**ITEM 4. DEVELOPMENT APPLICATION: HAROLD PARK - 10 MAXWELL ROAD - 72 AND 74 ROSS STREET - 1A AND 1B THE CRESCENT - FOREST LODGE****FILE NO:** D/2011/1298**SUMMARY****Date of Submission:** 17 August 2011. Amended plans and documentation submitted up until 28 June 2012.**Applicant:** Mirvac**Architect:** Hassell, Mirvac Design, ASPECT**Developer:** Mirvac**Site:** Harold Park (10 Maxwell Rd, 72 and 74 Ross St, 1A and 1B The Crescent, Forest Lodge).**Summary:** Stage 1 Development Application for the redevelopment of Harold Park.

**Summary Recommendation:** The development application is recommended for approval, subject to conditions.**Development Controls:**

**Figure 36 – The proposed building height in storeys. Two height controls apply. The Building 1C proposes 6 storeys in the 5 storey zone, shown boxed.**

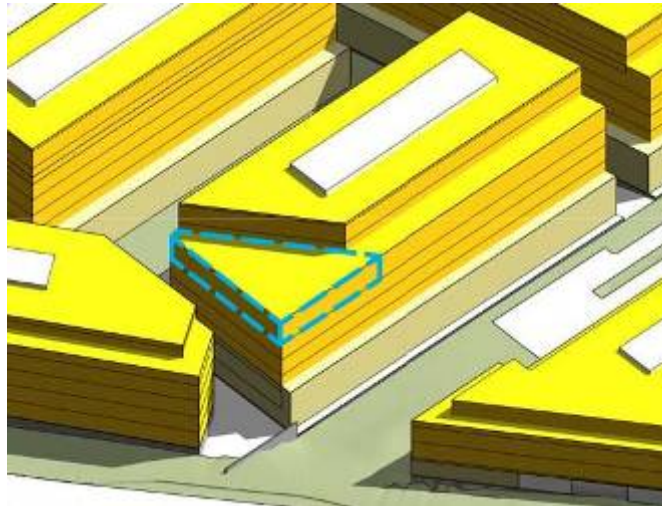
74. Building 1C is proposed to be 8 storeys with a 6 storey street frontage height. This means that the proposal exceeds the 5 storey height control by 1 storey in one portion of the site, as shown at **Figures 36 and Figure 37**. It is noted that Building 1C was amended to delete 2 storeys at this location as the original DA proposed 8 storeys.

75. Building 1C is an 8 storey building with levels 7 and 8 set back above the 6 storey street frontage height, as required by the DCP. The southwest corner is proposed to be 6 instead of 5 storeys. To comply with the controls, it is recommended that this element be amended to comply.

**Figure 39 – Western elevation (from The Crescent / Minogue Crescent) of Building 3D with the additional storey shown boxed.**

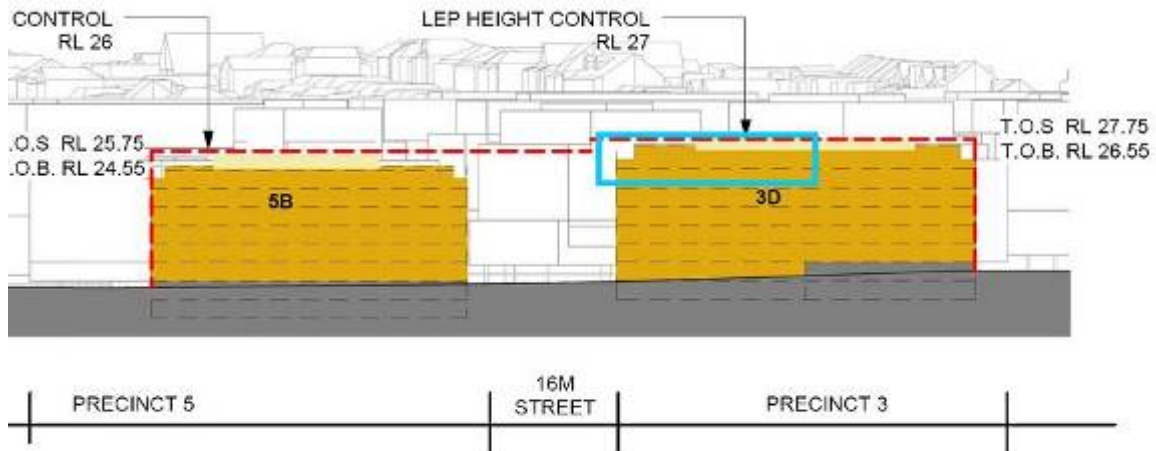
78. The DCP control for Building 3D is 6 storeys / 19.5m. Plans indicated that about half of the building is shown to be 7 storeys / 22.5m, exceeding the control by 1 storey / 3m. Refer **Figure 39** below.

79. It is noted that there is a discrepancy across the submitted plans with others showing that the proposed number of storeys for Building 3D is 6. In response to Council's request for clarification, the applicant advised 6 storeys is proposed. However, given that plans still indicate otherwise, Building 3D has been assessed as shown in **Figure 39** above.

Figure 40 – Section through Building 3D at the portion where the ground level sits 2.5m above The Crescent.

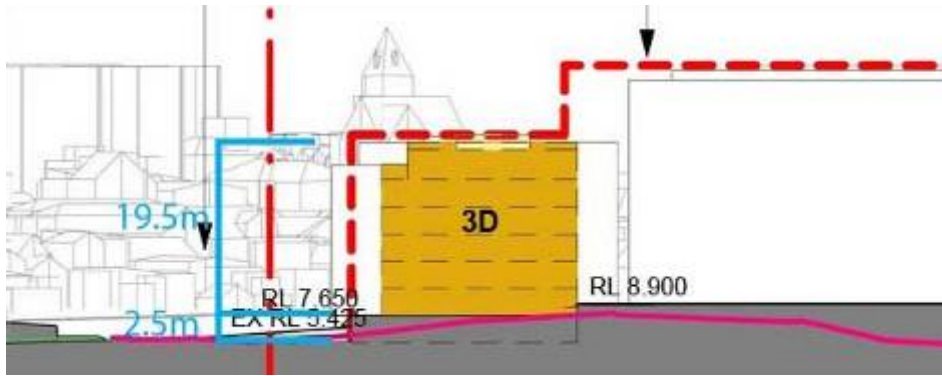
81. The 6 storey portion of the building complies with the height in metres controls when measured from ground level however ground level is 2.5m above Minogue Crescent. Refer to **Figure 40** below. The exposed basement can also be seen in elevation in **Figure 39** above.

- 82. The appearance of the building from The Crescent is higher than required as a result of the location of the ground floor and the building not responding to topography. This is not supported and appropriate conditions are recommended.

Figure 41 – Building 5A exceeds the height control by 3m. Compliance can be achieved in part by reducing the floor to floor heights of the lower levels.

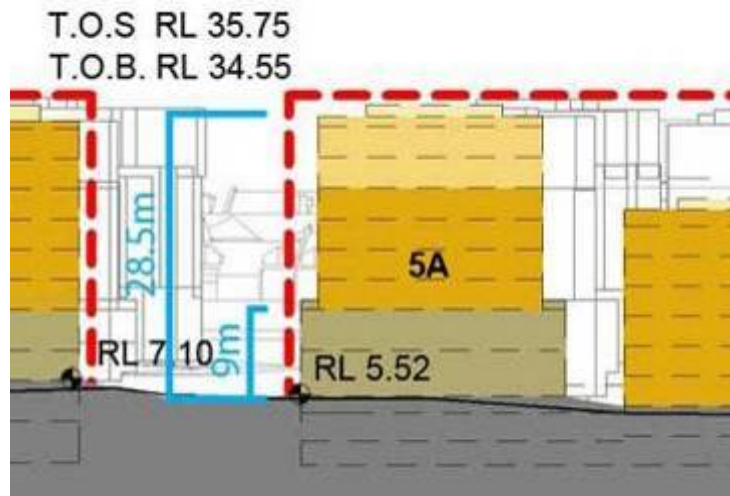
- 83. The DCP control for Building 5A is 8 storeys / 25.5m. The building complies with the 8 storey controls but its overall height is about 28.5m, exceeding the height in metres control by 3m. Refer to **Figure 41**.

- 84. A condition is recommended to require compliance with the height control.

**Figure 43 – Wigram Rd elevation of Precinct 6. Four storeys are shown at Wigram Rd. The DCP maximum is 3 storeys.**

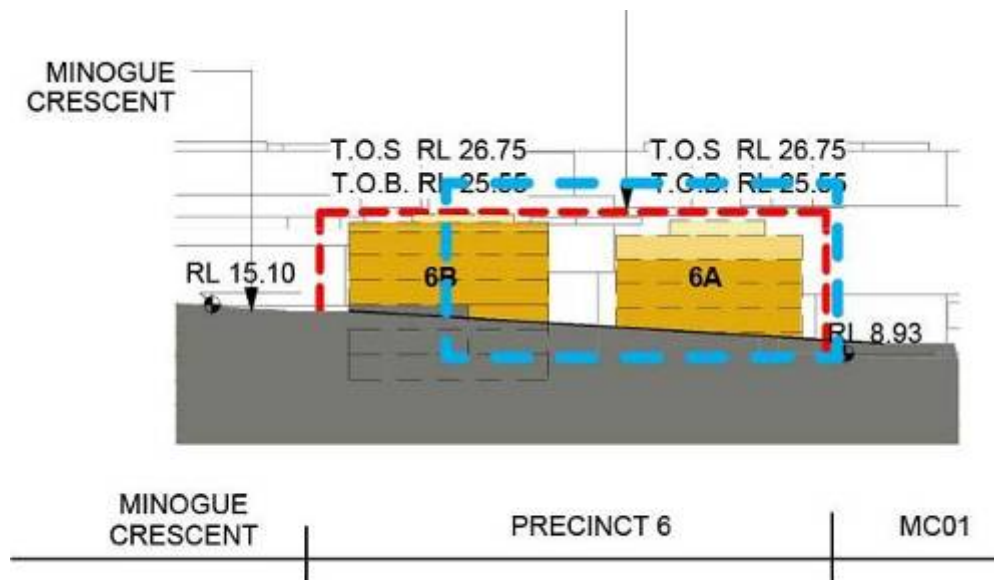
88. While the submitted storeys plan shows that Building 6A complies with the controls, the elevation plan (**Figure 43**) shows that the building presents as 4 storeys at Wigram Rd (over the maximum 3 storeys). While this may be a drafting error, to remove any doubt, an increase to the maximum number of storeys to Wigram Rd is not supported.

**Figure 44 - Section through Precinct 6, looking north. Two additional storeys are proposed to the courtyard on Building 6B.**

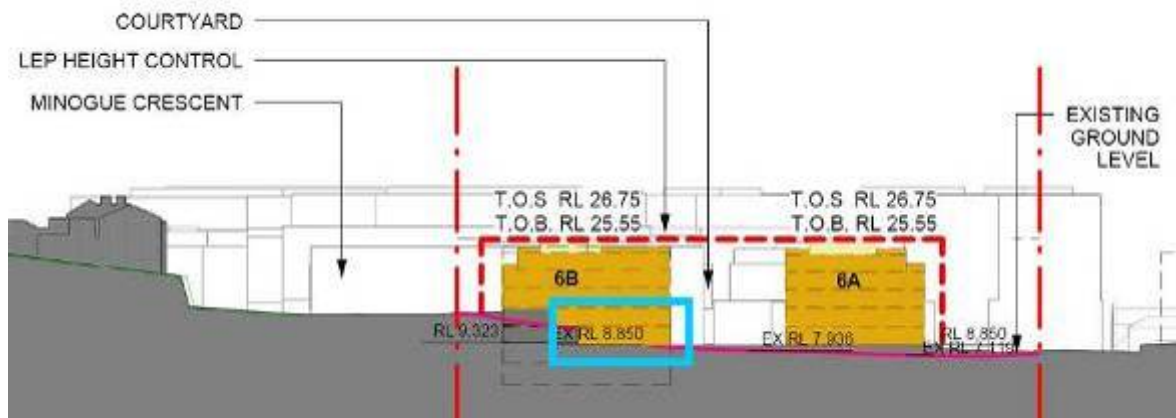
- 93. As a result of the site’s topography, Building 6B is proposed to be 4-5 storeys at the courtyard. Refer to **Figure 44** below. The proposed number of storeys to Minogue Crescent (between 3 and 4) complies with the DCP (see **Figure 45**).

94. While the additional part storeys resulting from the topography will not be visible from the public domain / Minogue Crescent, additional storeys cannot be supported at Stage 1 but, subject to demonstration of adequate amenity and solar access to future dwellings and compliance with FSR and other planning controls, may be considered acceptable with a detailed DA at Stage 2.
95. It is noted that the DCP requires 4 storey buildings to provide upper level setbacks. This means that above the 3<sup>rd</sup> floor, a setback of 3m is required. At this stage, no upper level setbacks are proposed along Minogue Crescent for Building 6B. This is discussed below under *Setbacks*.

**Figure 47 – Proposed lower level setbacks**

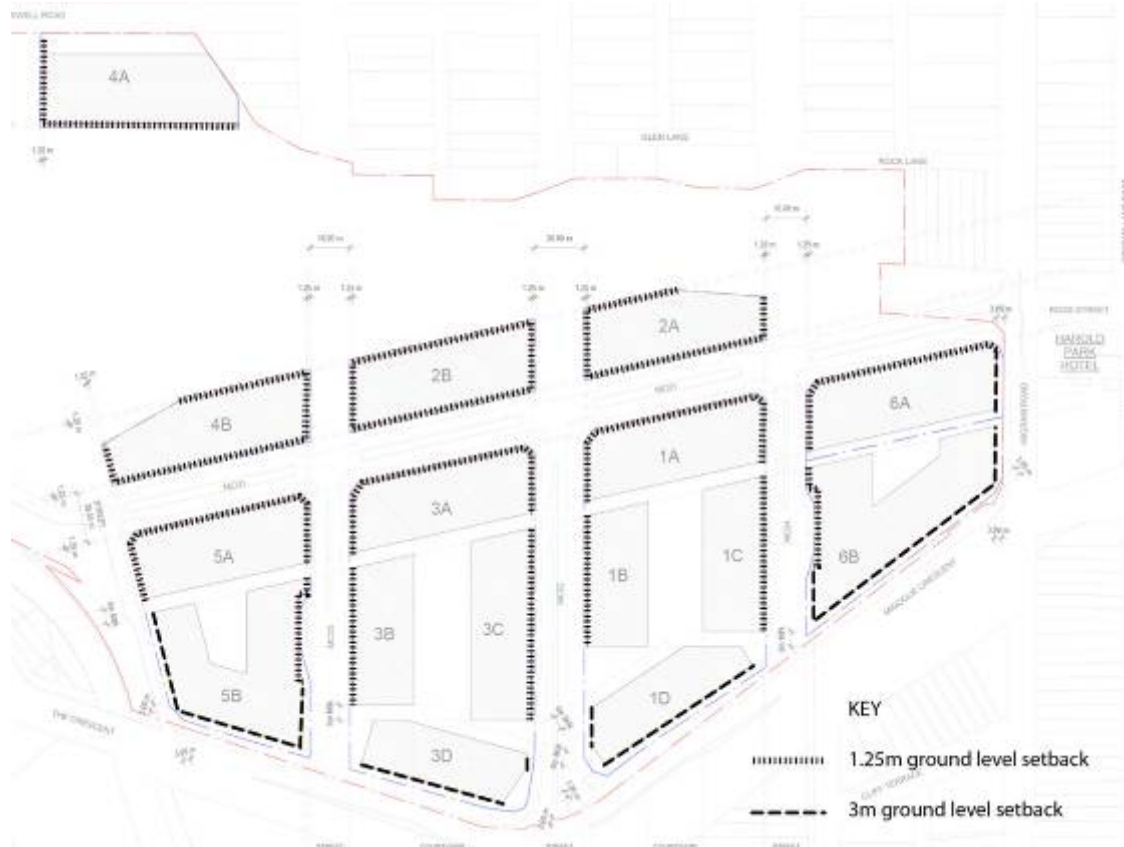
99. With the exception of Building 4A (discussed below), reduced setbacks in the locations shown in **Figure 47** are supported. It is considered that the introduction of this building typology is considered to have streetscape merit, will provide a human scale to the development, is complementary to the character of the area and will create opportunities for interesting architecture.

105. It is also noted that the splayed elevations of buildings 2A and 4B propose nil setbacks. Refer above to **Figure 47**. This is considered acceptable as a setback in these locations is of less value as the splay narrows the buildings which in turn increases the width of the future park in these locations.

Figure 49 – The hatching shows where buildings are proposed to maintain the 1.25m lower level setback only and not be set back 3m.

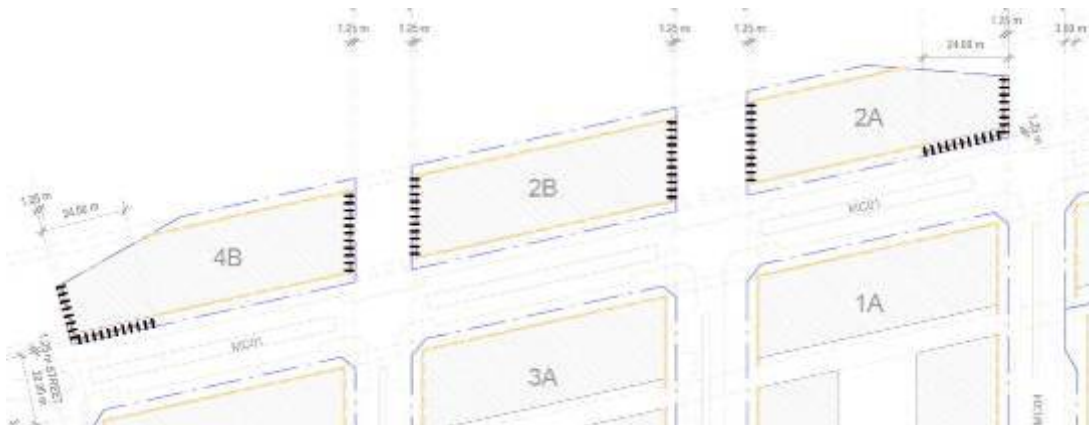
108. As shown in **Figure 48** above, the only non-compliance typically occurs at the ground and first floor, which is supported. However, proposed variations to the mid level setback controls are proposed to the parkside buildings (2A, 2B and 4B). Along some elevations, these buildings are proposed to maintain the 1.25m lower level setback and not be set back 3m, as shown below in **Figures 49** and **50**.

109. The lesser setbacks between the buildings may be supported subject to the appropriate design of these elevations and compliance with upper level setbacks, where required. Refer to discussion below under the heading “Upper level”.

**Figure 51 – Proposed upper level setbacks with areas on non-compliances circled.**

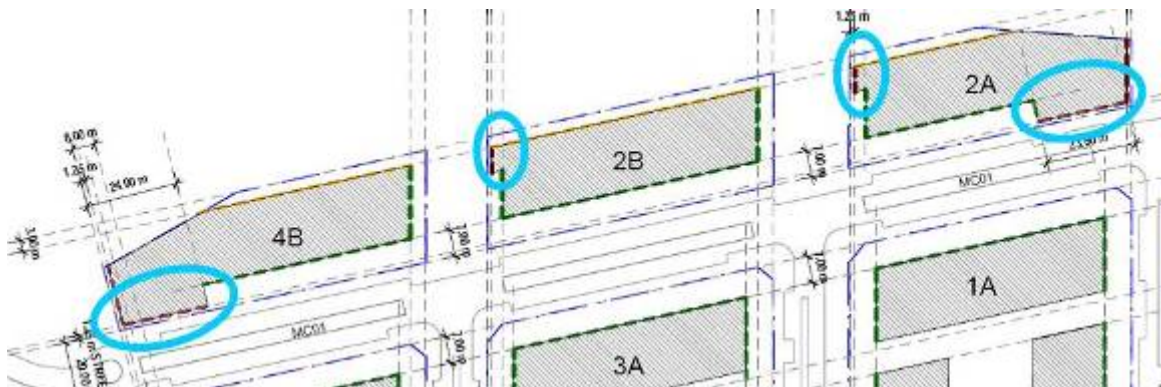
118. Put simply, complying setbacks would mean the areas shown circled above on **Figure 51** would not 'pop-out'.
119. The northern 'pop-out' sections of Buildings 2A and 2B are not supported as these buildings already propose a reduced setback on the lower levels. Upper level setbacks are required to provide an appropriate transition in scale, reduce the apparent height and bulk of the buildings and open up views to the sky for pedestrians approaching the park. The open spaces between these buildings will be key entrances into the future park and they should feel as open and welcoming as possible.

**Figure 52 – Proposed upper level setbacks for Buildings 5A and 5B.**

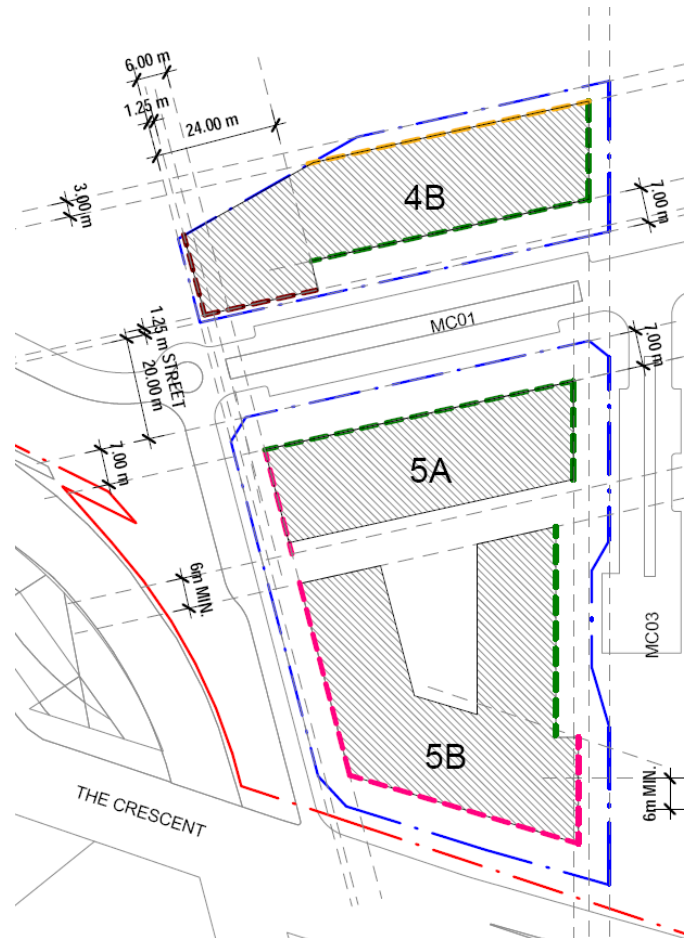
123. Building 5A also proposes a setback variation. As this building is an 8 storey building, a 7m upper level setback is required (measured from the boundary or 4m measured from the street frontage height). A 6m setback is proposed.
124. The 1m variation is supported as the setback is consistent with the upper level setback proposed for Building 5B to the west. See **Figure 52**. A lesser setback of 6m (compared to 7m) applies to Building 5B as it is a 6 storey building and it is acceptable that Building 5A provide the same setback.

**Figure 53 – Building levels plan shows no upper level setbacks along Minogue Crescent for Building 6B.**

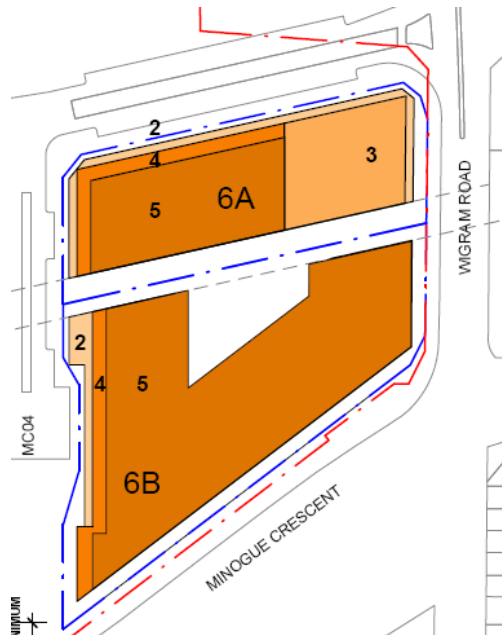
125. The maximum height of Building 6B along Minogue Crescent is 3 to 4 storeys. The DCP requires 4 storey buildings to have a 3 storey street frontage. This requires the 4<sup>th</sup> storey to be set back 3m.
126. At Minogue Crescent, Building 6B is 3 to 4 storeys and complies with the height control, however no upper level setback is proposed. Refer to **Figure 53**.

127. As discussed previously, objectives of the DCP in relation to height seek to ensure that the scale of the development reduces along the western and southern edges of the site to respond to the scale and character of the surrounding area. In addition to overall height, this is achieved by setting upper floors back.
128. Variations to the required upper level setbacks in this location should only be the subject of a detailed Stage 2 DA. Appropriate conditions are included in the recommendation.

Figure 54 – Building entries to be considered off The Crescent / Minogue Crescent.

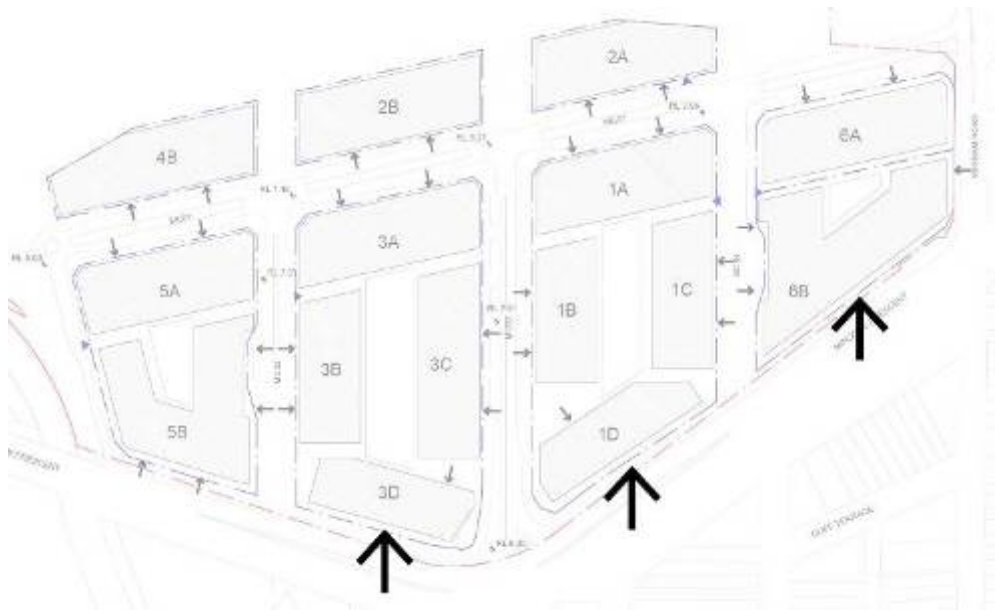
132. Buildings D, 3D and 6B have no building entries from Minogue Crescent and The Crescent. This does not contribute to the activation of the streetscape or create a legible 'front door' to the buildings.
133. Conditions are recommended to consider the benefits of entry lobbies from Minogue Crescent and The Crescent, as shown in **Figure 54** below.

Figure 55 – Proposed driveway crossings for Precinct 6.

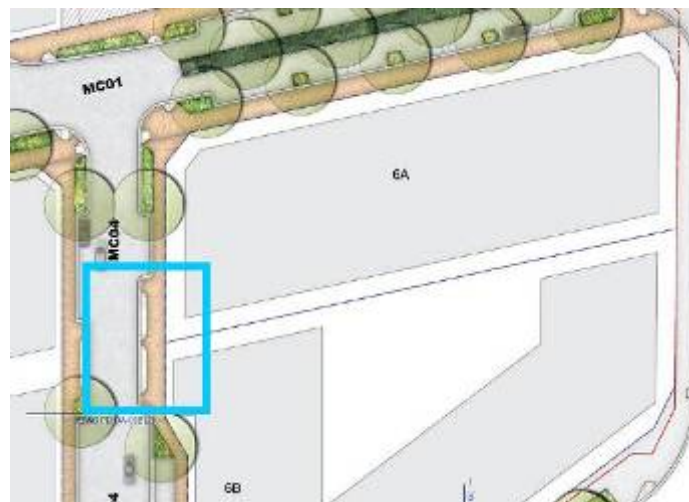
134. Precinct 6 is comprised of 2 sites – Site 6A, identified for affordable housing and Site 6B. Plans show 2 driveway crossings side by side. This reduces pedestrian amenity, street parking and opportunities for landscaping. While these lots will be in separate ownership and may be developed at different times, it is considered appropriate that when the first DA for Precinct 6 is submitted, opportunities for a shared driveway are investigated. A condition has been recommended.

Figure 58 – Proposed median with pedestrian refuge.

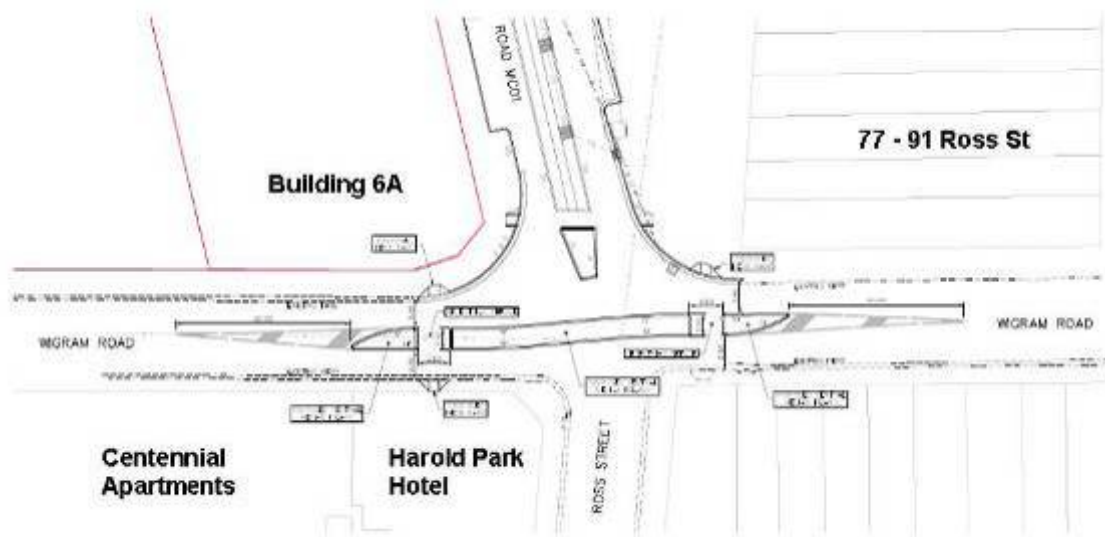
187. A median is required at the realigned intersection of Ross Street and Wigram Road to prevent turns from Ross St onto Wigram Rd. This is to reduce traffic impacts to local streets and prevent 'rat runs' from the Harold Park site crossing Wigram Road and travelling south on Ross St.
188. The median has been redesigned to include a pedestrian refuge to improve pedestrian and cyclist safety and provide safe access to the new park from the south. Refer to **Figure 58**.

189. The City supports the proposed median as shown in **Figure 58** which restricts all movements at the intersection to left turns only. The median provides refuge for pedestrians and cyclists, improves safety for road users and enforces an existing timed right turn movement ban. The median does however result in some residents to the south of Wigram Road needing to use an alternative route to get to their homes.
190. Residents of 115 Wigram Road (Centennial Apartments) have raised concerns about the impact of the proposed median on vehicle access to their property. In response to those concerns, an alternative design was developed by Mirvac which enables right-hand turns into Ross St. Refer to **Figure 59**.

Figure 59 – Alternative median design which allows right hand turns into Ross St.

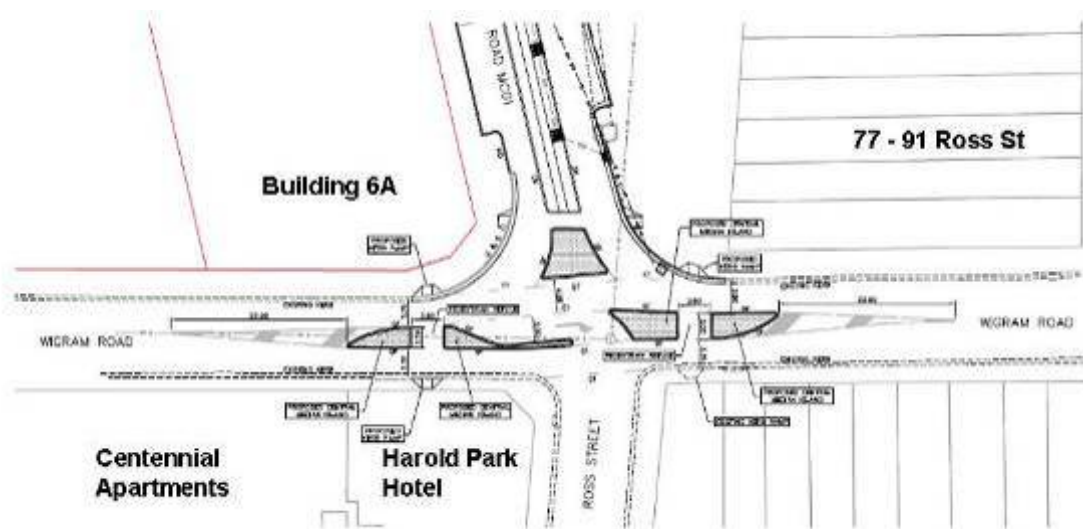
191. The alternative design is not supported for the following reasons:
- (a) the design would allow a right turn movement, which is a movement that is currently prohibited (and will continue to be) during the weekday AM peak (6.30am – 9.30am);

- (b) given the current ban identified in (b) above, the provision of a turning facility will create confusion over the restriction on the movement resulting in potential safety issues;
  - (c) potential for vehicles waiting to turn right, to queue beyond the length of the bay and into the Wigram Road eastbound traffic lane.
192. The alternative access that residents of 115 Wigram Road will need to use as a result of the median is shown below at **Figure 60**.

**Figure 62 – The proposed loading area on Maxwell Road to service Building 4A is shown boxed.**

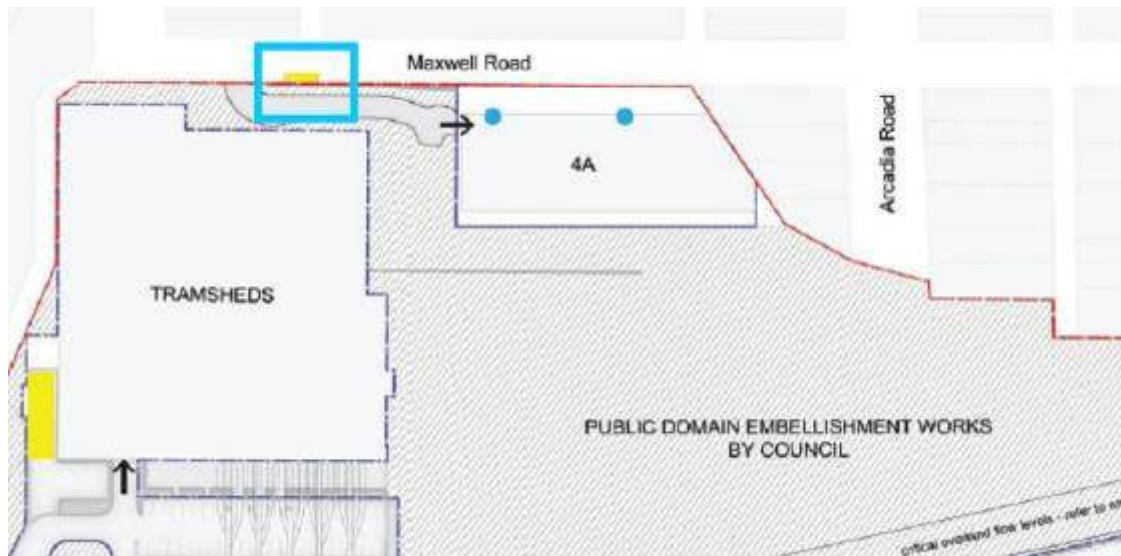
209. It is noted that while on street loading and waste collection is generally acceptable on this site, it is not supported for Building 4A. This building has no direct road frontage as it sits below the Maxwell Road level. Access to Building 4A will be off Maxwell Road via a shared zone that will be the main access for pedestrians and cyclists from the site to the light rail. Pedestrians have priority on a shared zone. Refer to **Figure 62** below.
